INITIAL FIRE SAFETY INSPECTION REPORT

SAIHAM KNIT COMPOSITE LTD. (Extension 2)

RSC ID: 24576

Date: 16 January 2025

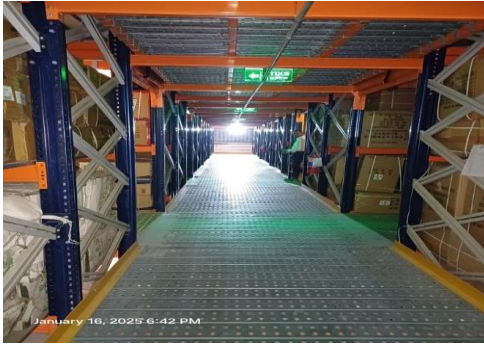
F-13	Fire Rated Construction	Areas used for combustible storage open to the factory are not maintained or separated by fire rated construction. Location: Dyeing Building.	Separate the dedicated storage rooms by minimum 1-hr fire-rated construction. Provide 0.75 hr. fire rated door and seal all penetrations and openings by 1 hr. fire rated fire rated barrier construction. Where separate storage rooms are not feasible, provide defined storage areas and limit the storage arrangement as follows: - Maximum height of 2.45m (8ft.) , maximum area of 23m2 (250 ft2) and 3m (10ft.) clear distance from adjacent another unenclosed combustible storage. - If the building/floor is sprinkler protected: maximum height of 3.66m (12ft.) and maximum area of 93m2 (1000 ft2). -In process storage shall be limited to 10 percent of the building area of the story in which they occur.	Within 2 months
------	-------------------------	--	---	-----------------
